ADDENDUM #ONE (1)

project Spirit Mountain Chalet
Duluth, Minnesota
project # 011103.00
date May 7, 2012
from John M. Gerzina DSGW Duluth
to All plan holders for above project

2 of 6

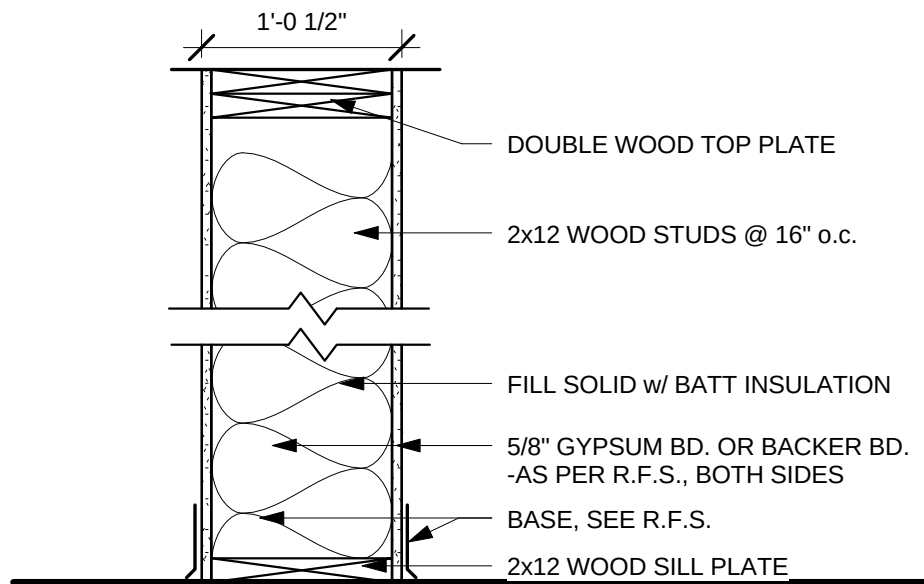
1. ADD Wall Type 12A as shown on the attached Addendum Drawing 2 of 6.
2. 10, 11 & 12/A4.1: CLARIFICATION: Exterior wall finish shall be 24 gauge prefinished metal panels to match window frame color. Anchor to wall sheathing with construction adhesive and concealed fasteners and wrap & return and terminate 1" inside window frame face. This detail is similar at all wall mullion conditions as shown on the drawings to be finished with pre-finished metal. This work to be by the aluminum window contractor.
3. 12/A4.1: CLARIFICATION: Gypsum board shall wrap & return to face of aluminum frame and be finished with J-bead.
4. CLARIFICATION: All aluminum windows and HM frames to receive continuous sealant around exterior and interior perimeter.

12A

FULL HEIGHT - TERMINATE AT BOTTOM
CHORD OF ROOF TRUSS OR FLOOR DECK

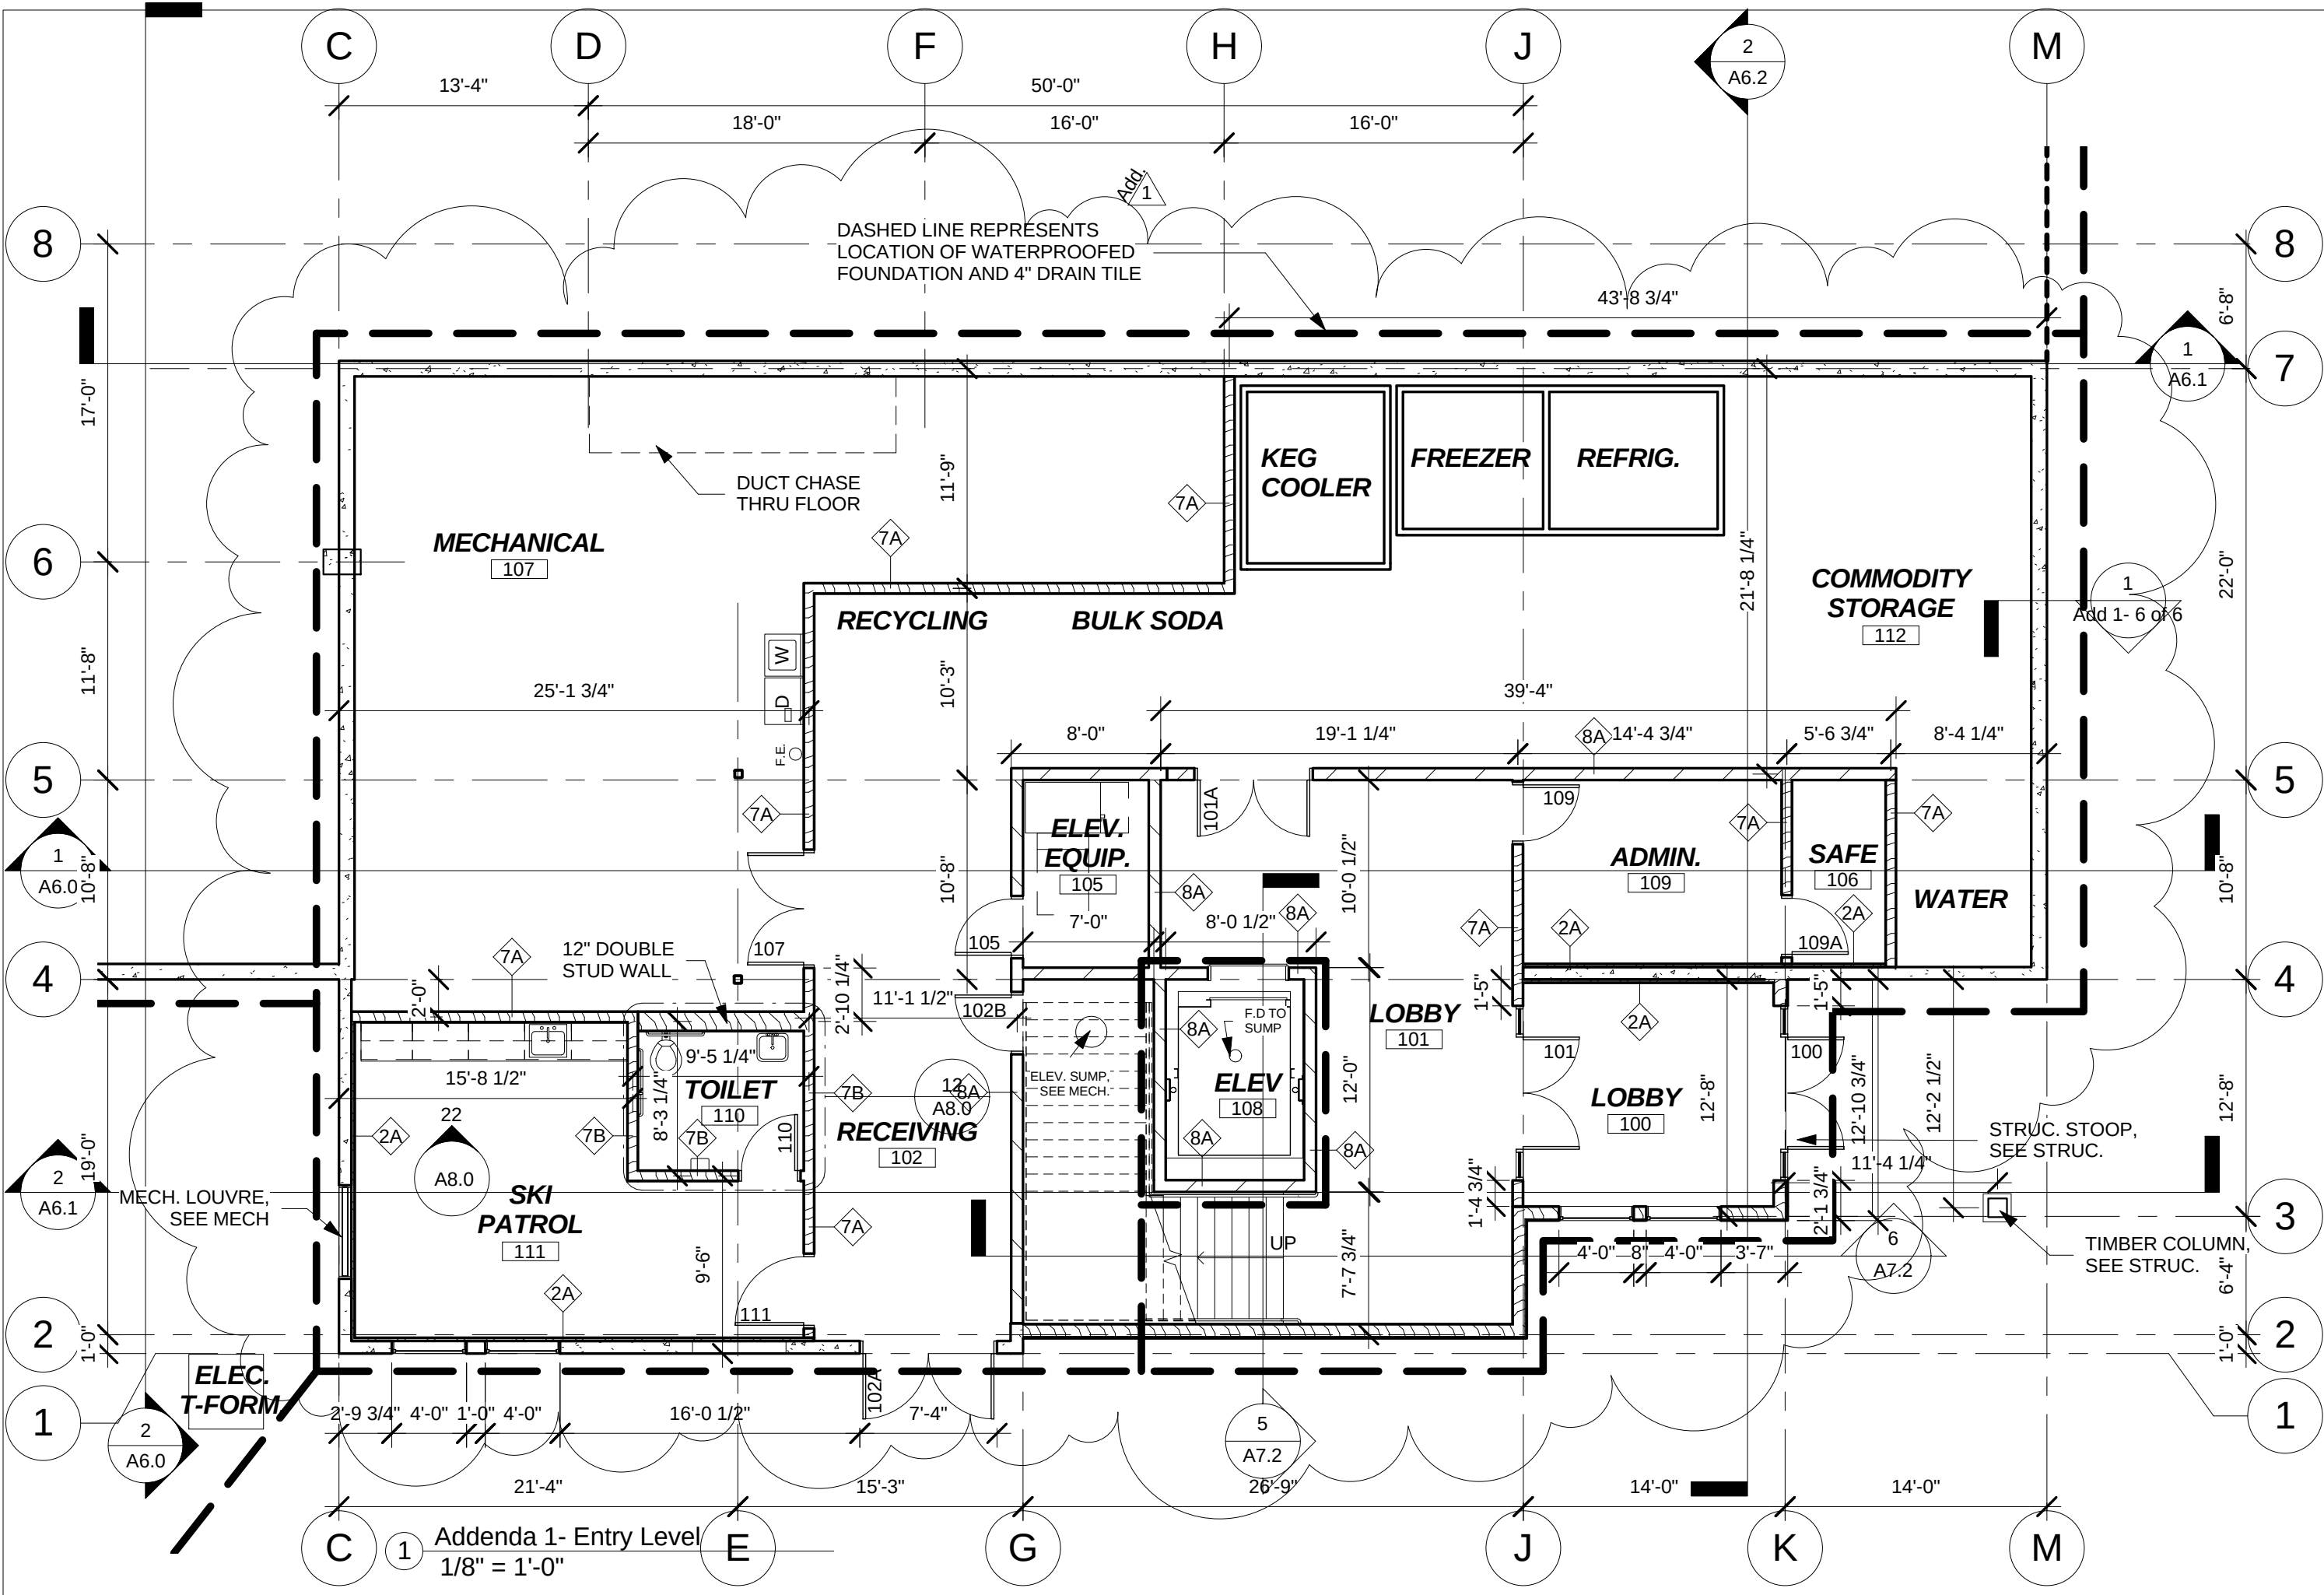
1. See attached drawing 3 of 6 for revised drain tile to be around basement portion of foundation wall as well as frost foundation.
2. DELETE Door 102B and install a 2'-8" x 3'-4" access panel mounted 8" off of the floor.
3. CLARIFICATION: CMU walls and all openings at the elevator shaft & the elevator equipment room shall have a one hour fire rating.
4. See attached drawing 5 of 6 for trash enclosure.

4 of 6

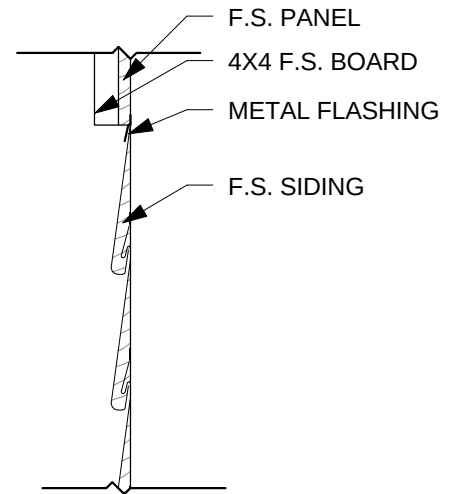
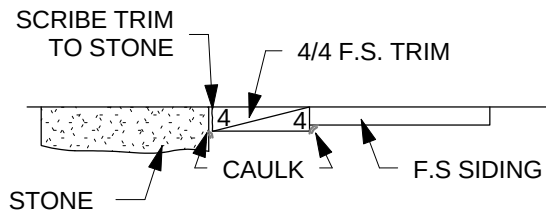
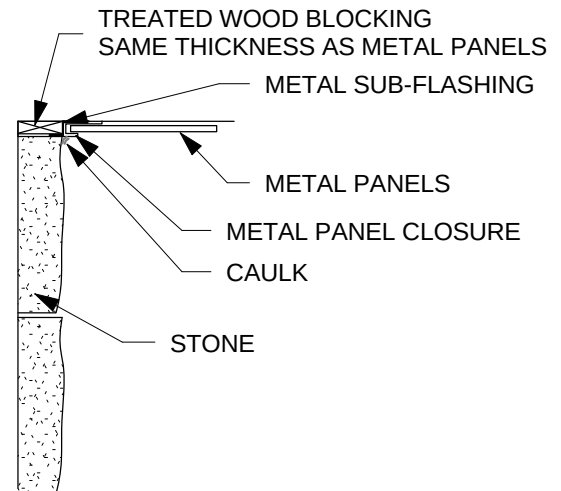
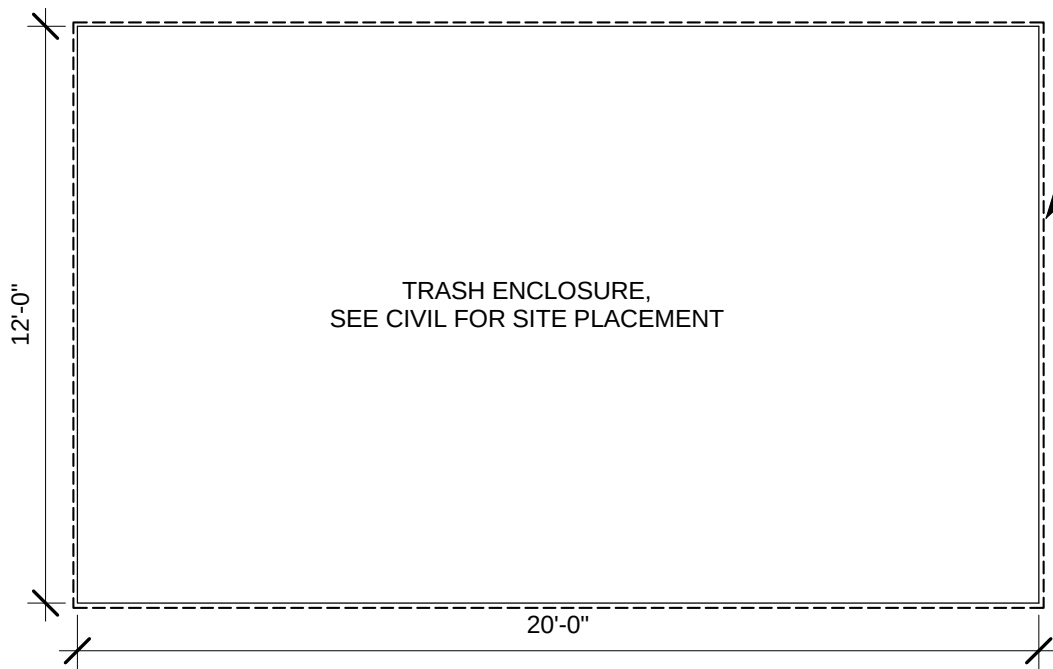
1. See attached drawing 4 of 6 for transition details of exterior finish materials
2. CLARIFICATION: All metal trim shall match aluminum window frame color.

6 of 6

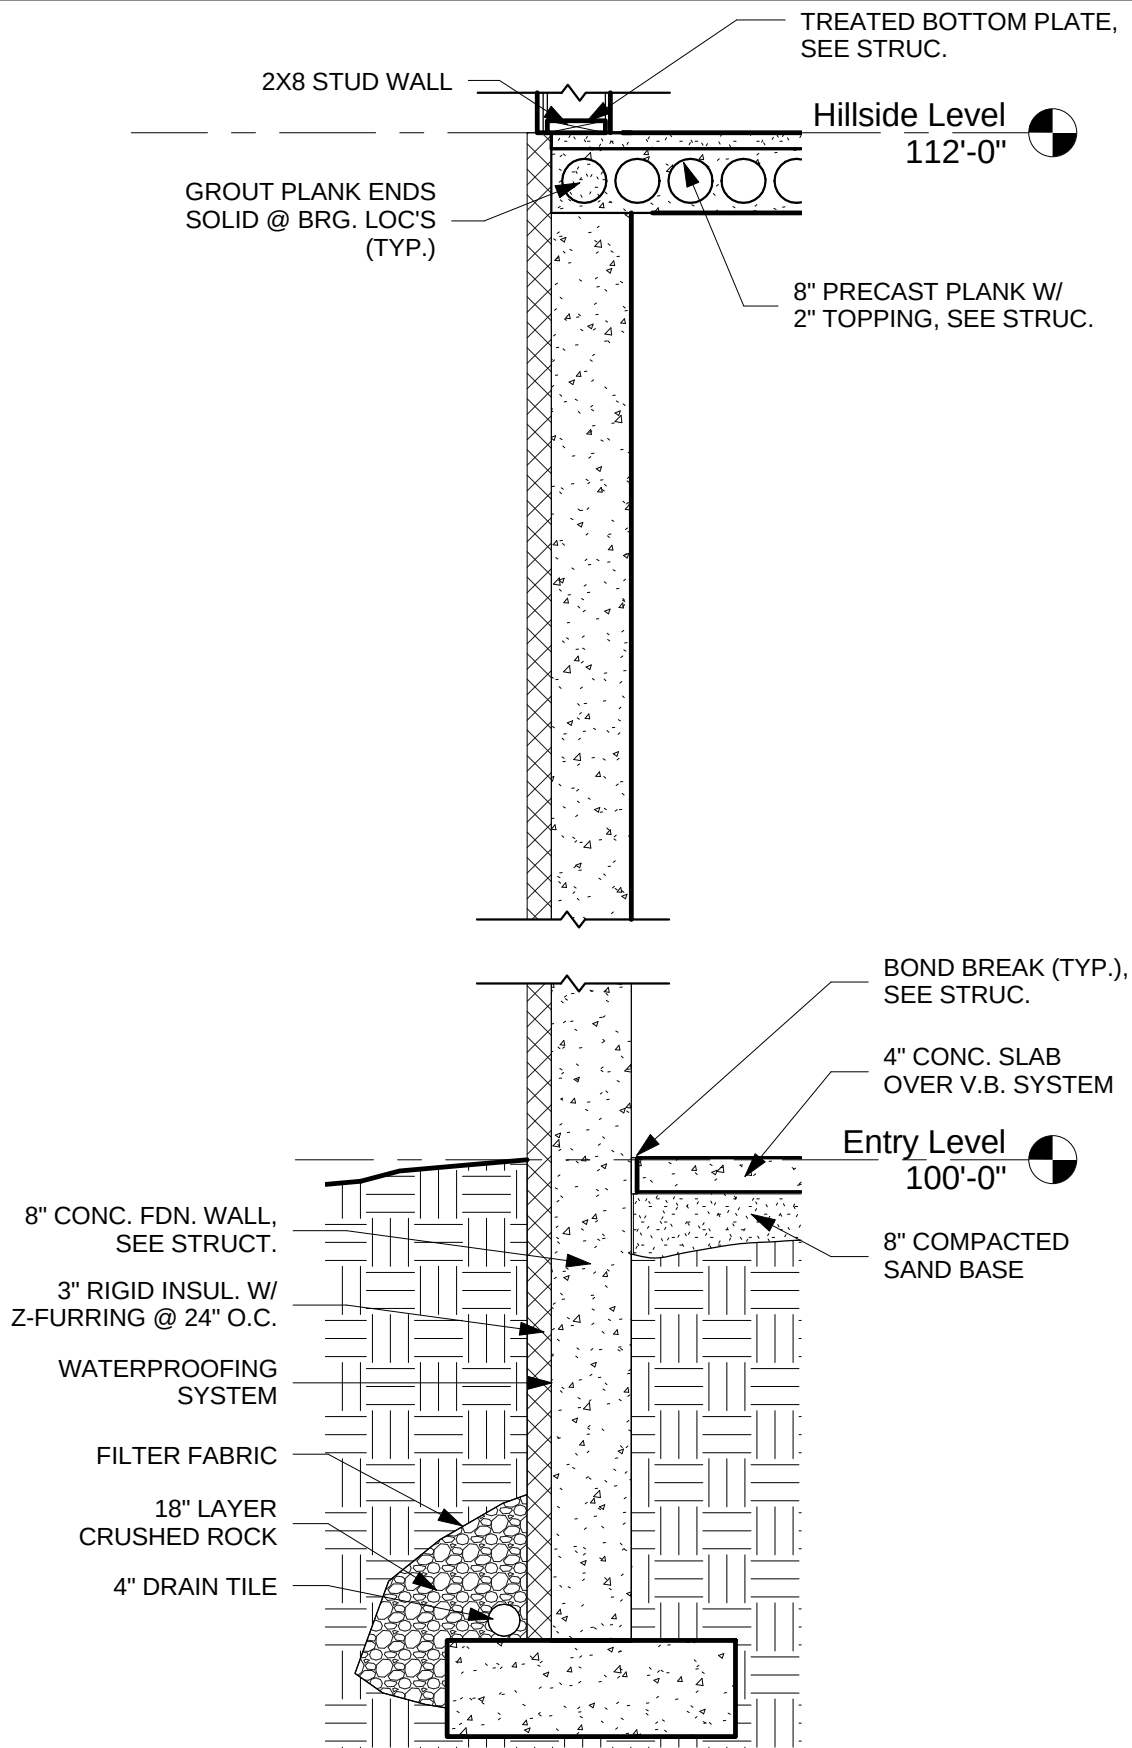
1. CLARIFICATION: All basement walls (defined as those walls retaining dirt from interior rooms), general located along Grids C, Grid 7 and Grid M shall receive sheet waterproofing. See attached drawing 6 of 6 for typical foundation wall waterproofing, insulation & drainage systems. |

1. 1 & 2/A7.1: CLARIFICATION: All metal z-furring shall be installed at 16" on center.
2. 2/A7.1: DELETE reference to 1x8 cedar soffit notation.
3. ADD 3/A7.1 as shown on the attached drawing 6 of 6.
